Project No. 2022\_110

## Midlothian ISD Baxter ES Kitchen Upgrades

### ADDENDUM NO. 2

March 20, 2023

1 FIRST FLOOR DEMO PLAN  
1/8" = 1'-0" REF 5 / A-101

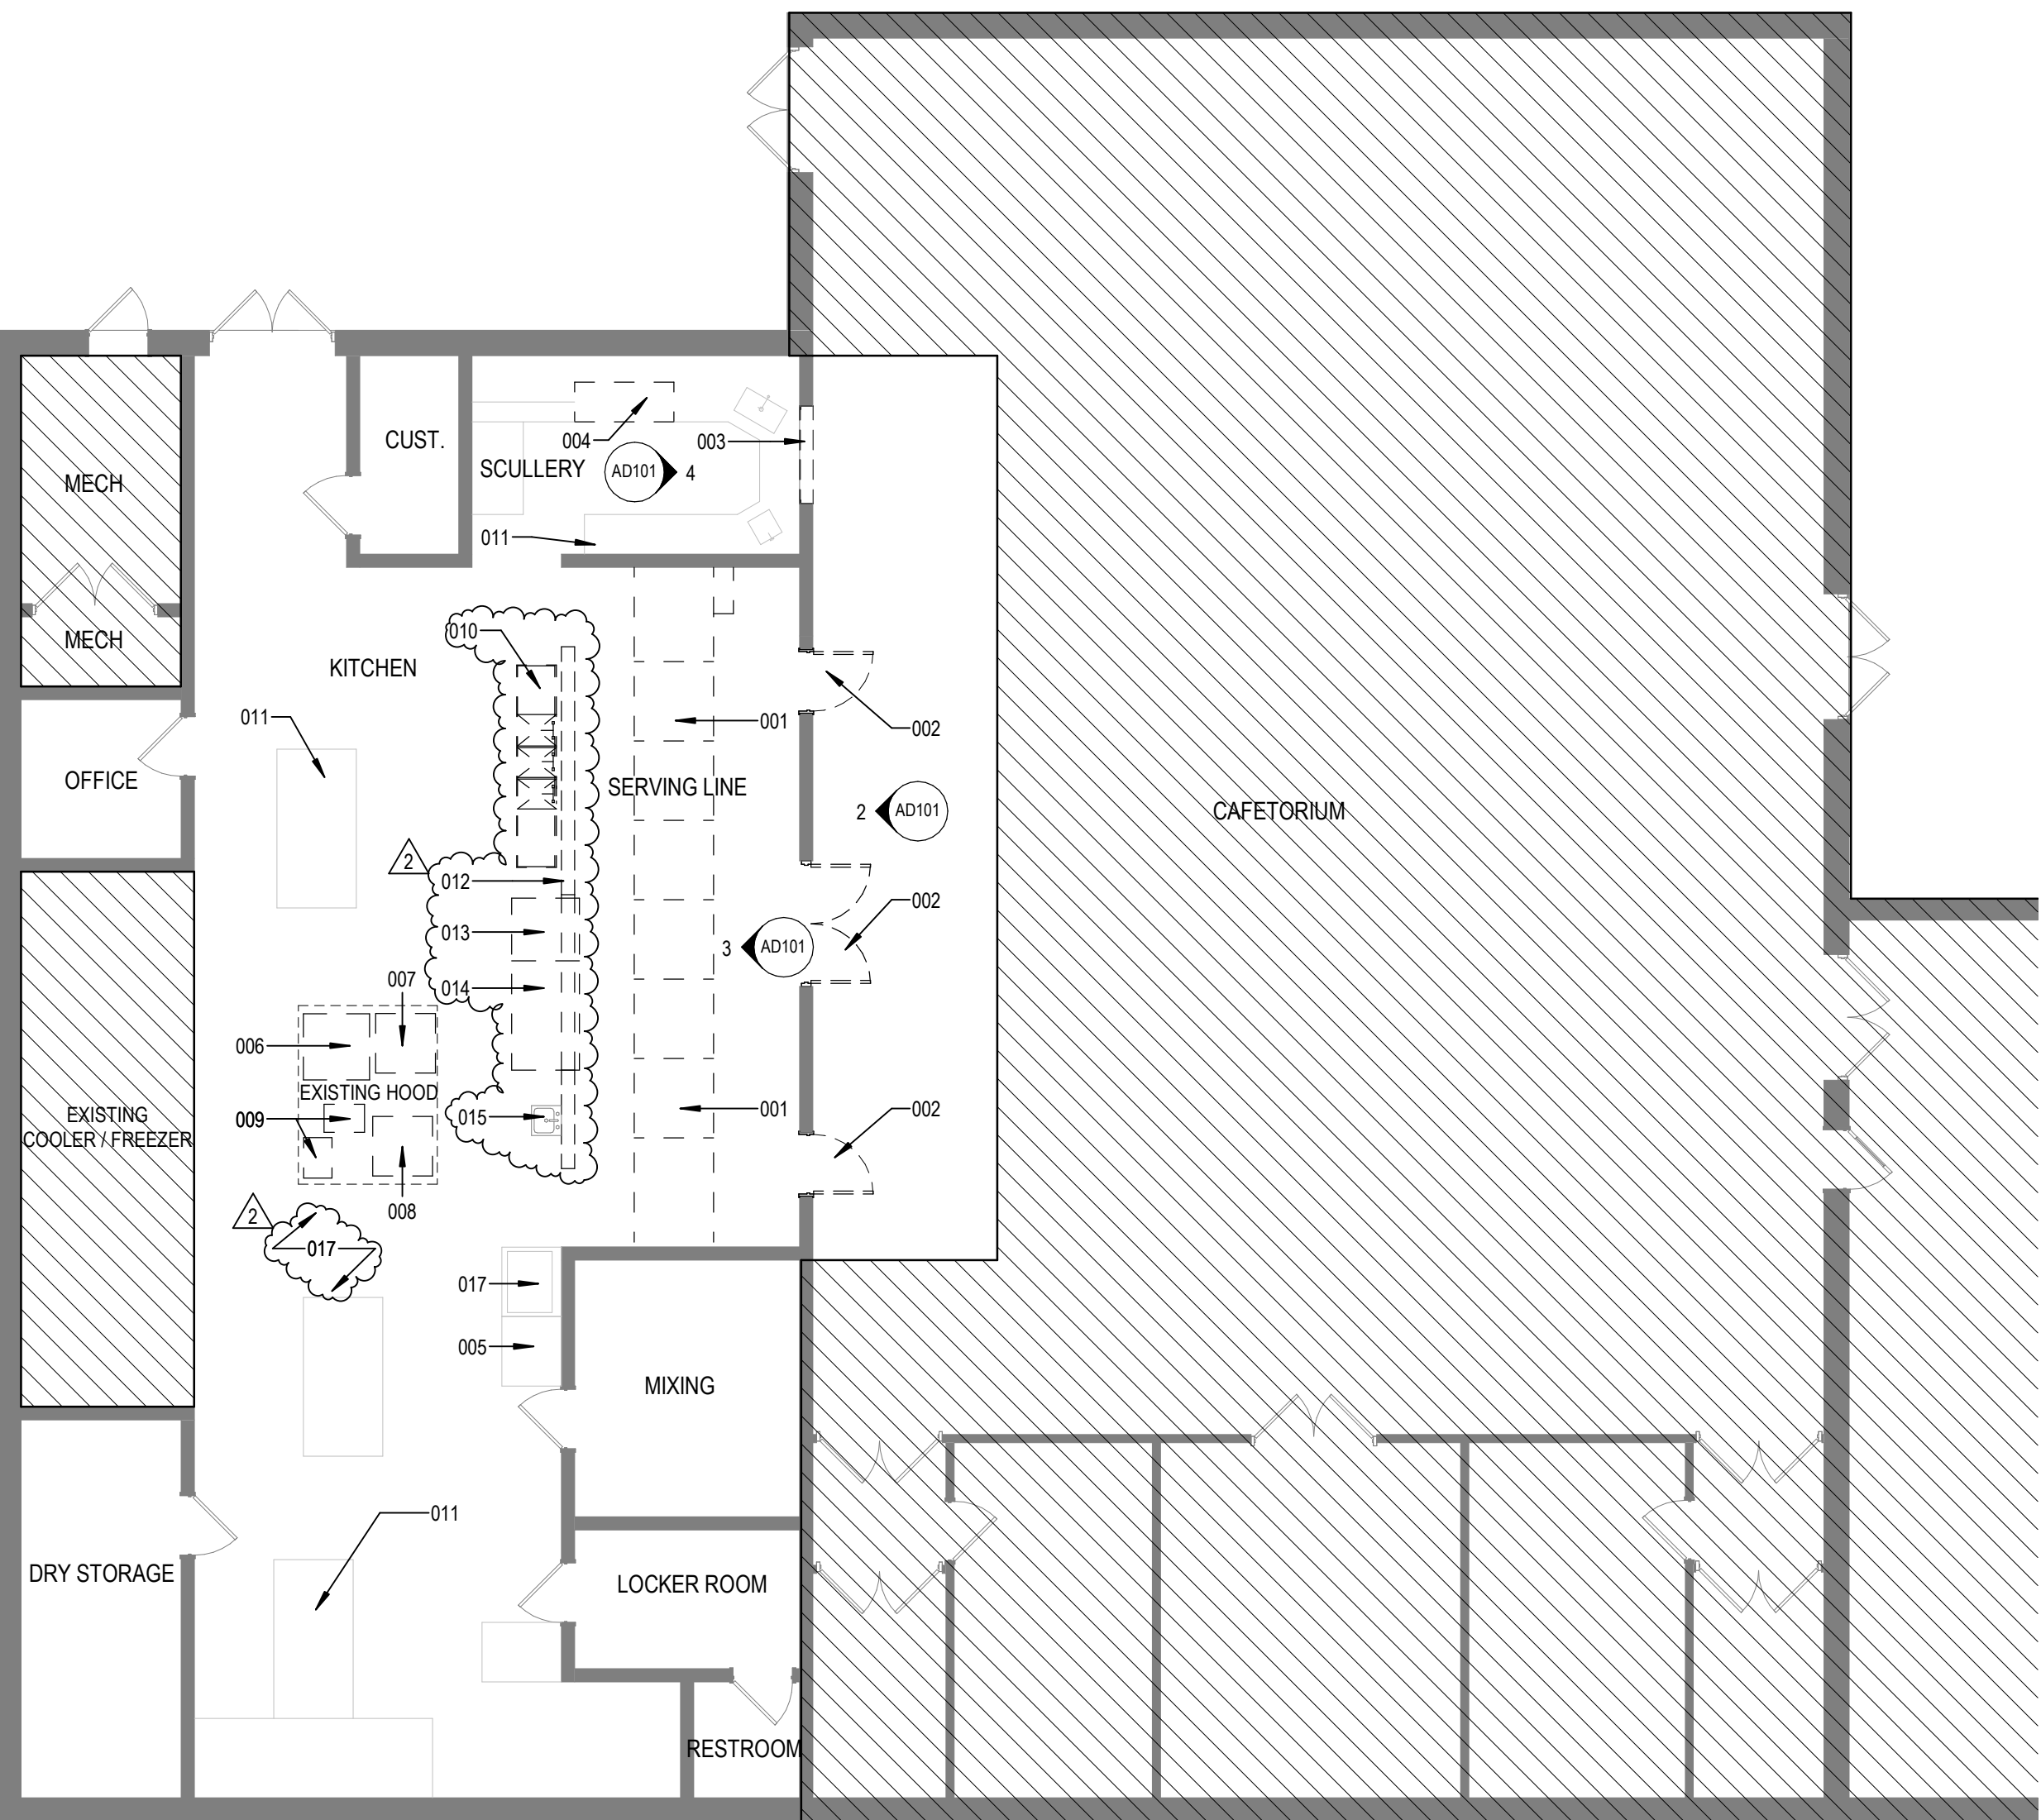
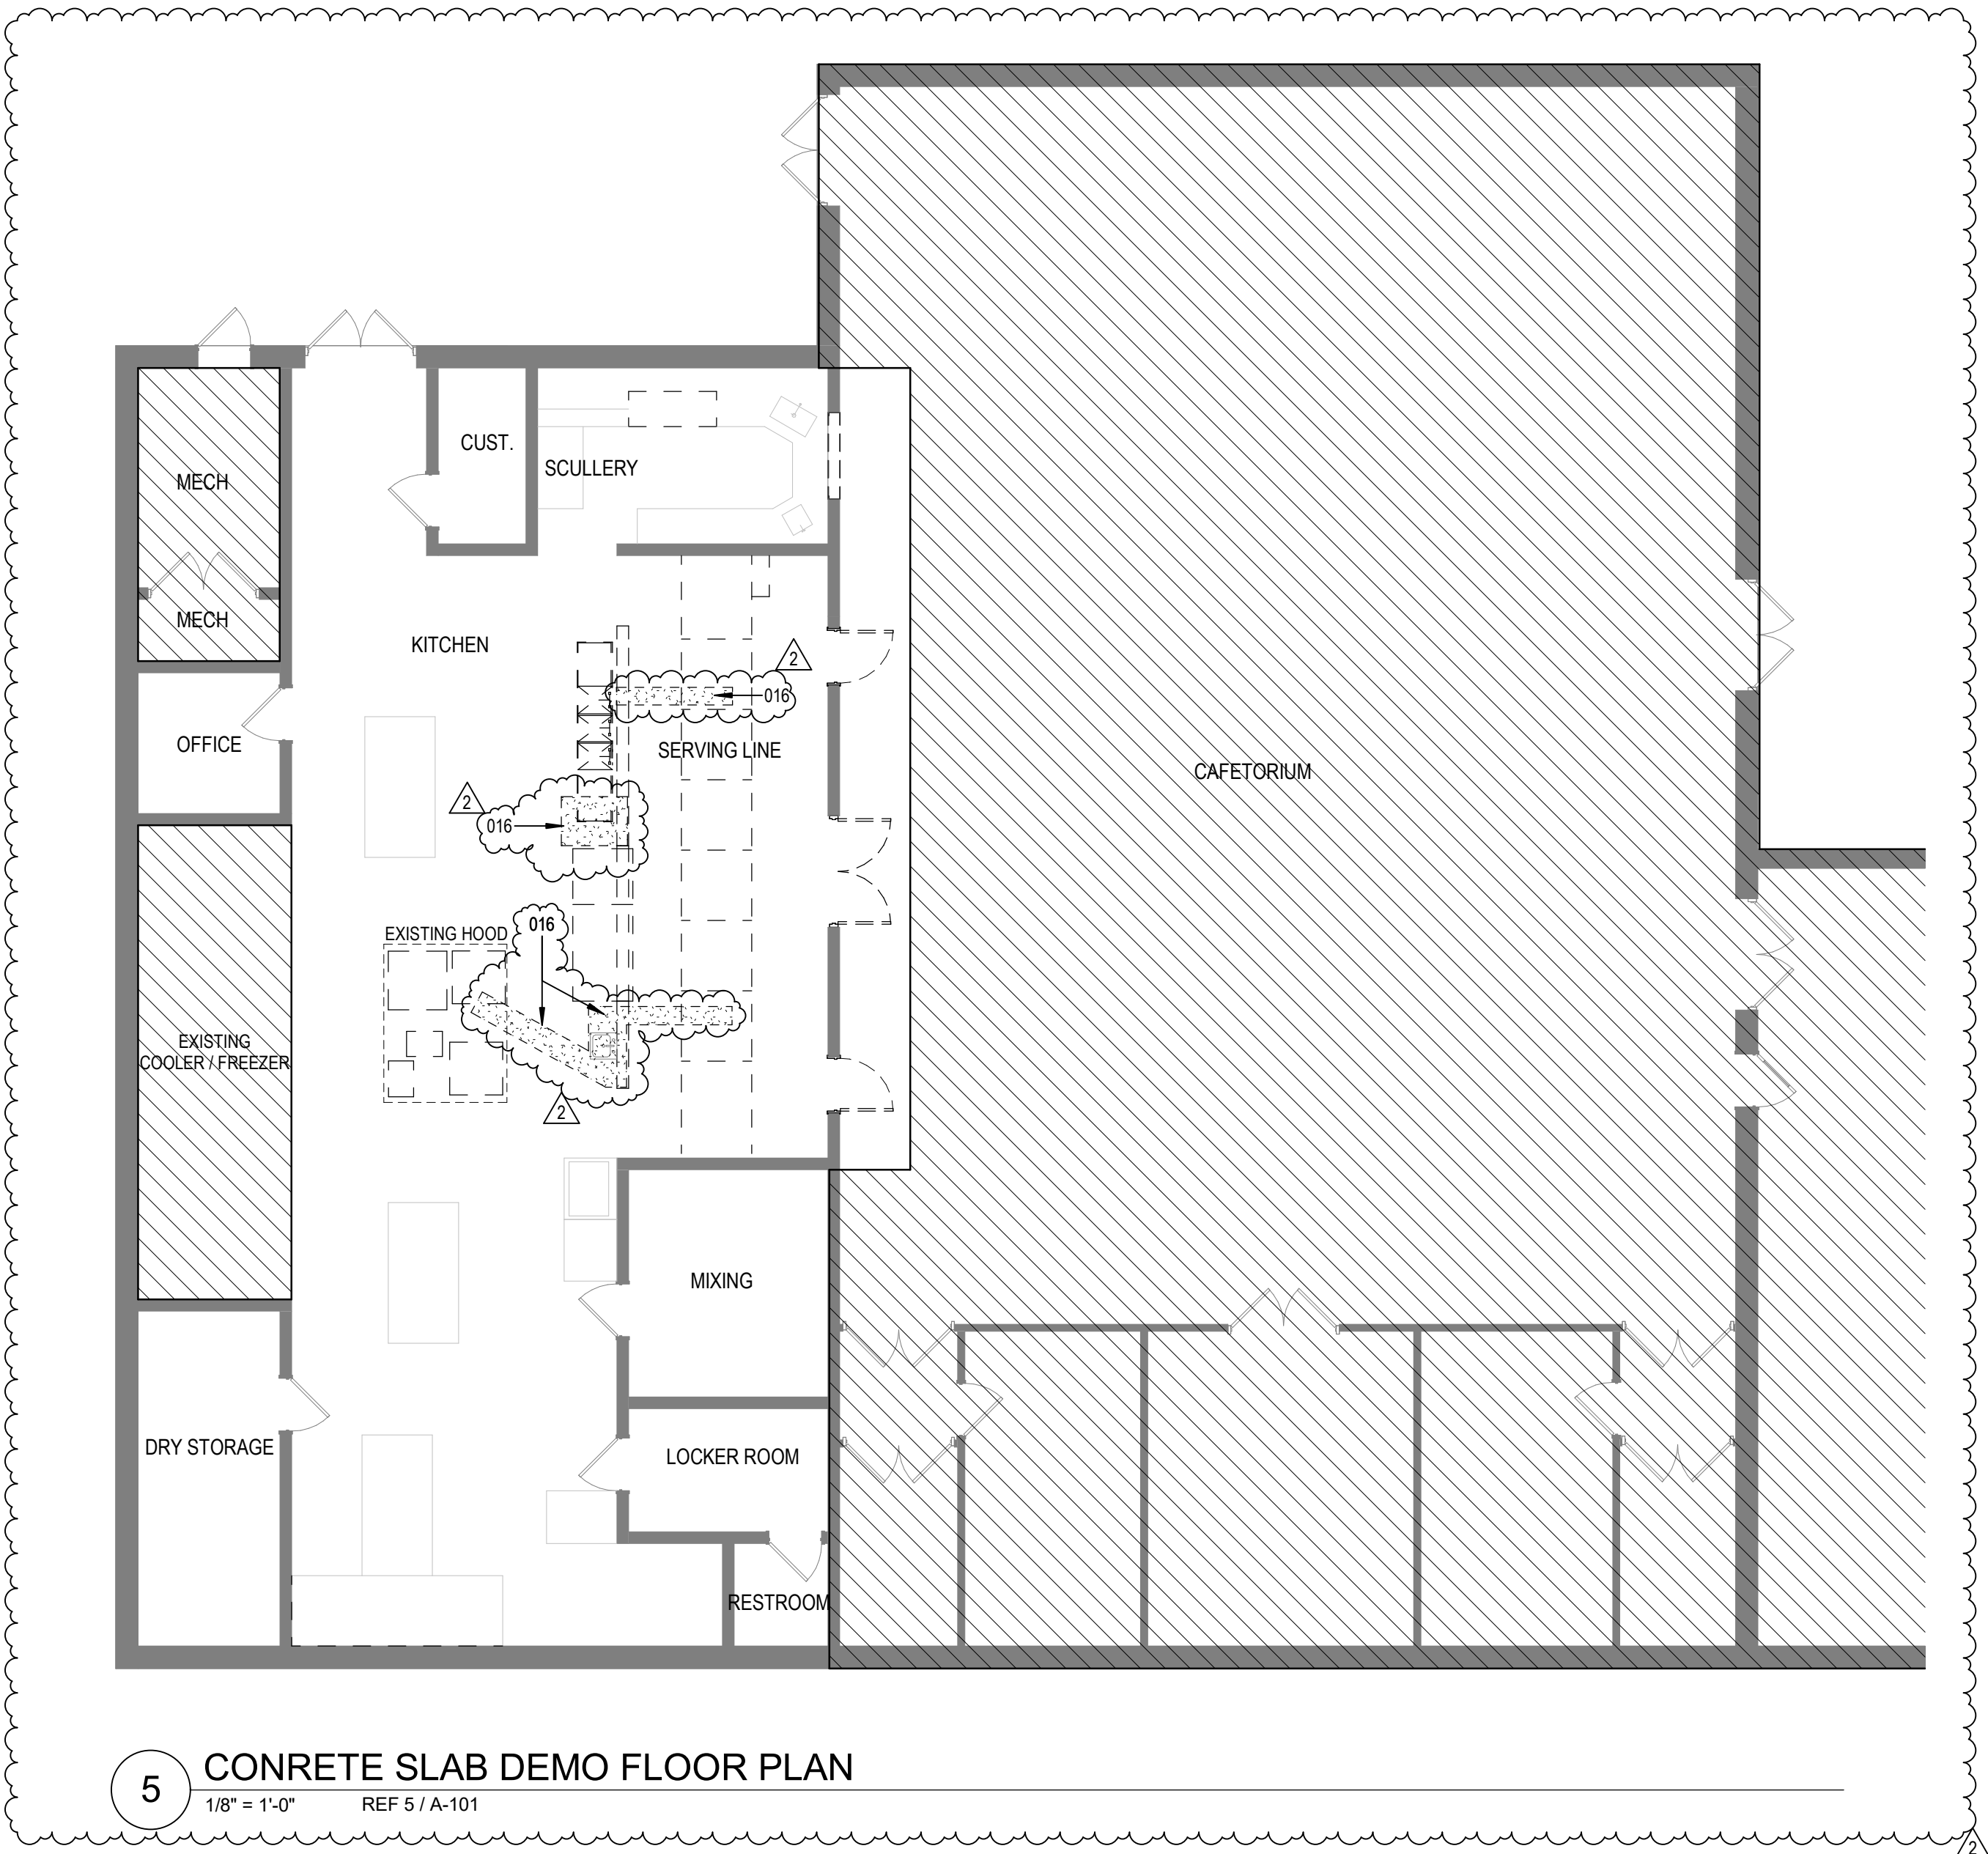
2. *Could a plan be provided for the slab saw cuts, for all trades, on one plan page?*

11. *Some talk at the pre-bid about removing the CMU wall in the kitchen in its entirety?*

12. *FS Equipment noted to be moved to Cafetorium has no notes to be moved back?*

##### ITEM NO. 02 AD101 - DEMOLITION PLANS

Please refer to attached Sheet AD101 DELTA 2 ADDENDUM#2

Yes, remove the wall entirely. Please refer to attached sheet 1/AD101 DELTA 2 ADDENDUM#2

Done, notes have been added. Please refer to attached sheet 1/AD101 DELTA 2 ADDENDUM#2

Replace this sheet in its entirety. The sheet shows saw cuts locations for existing concrete floor all in one location per the request in bidder question no. 2.
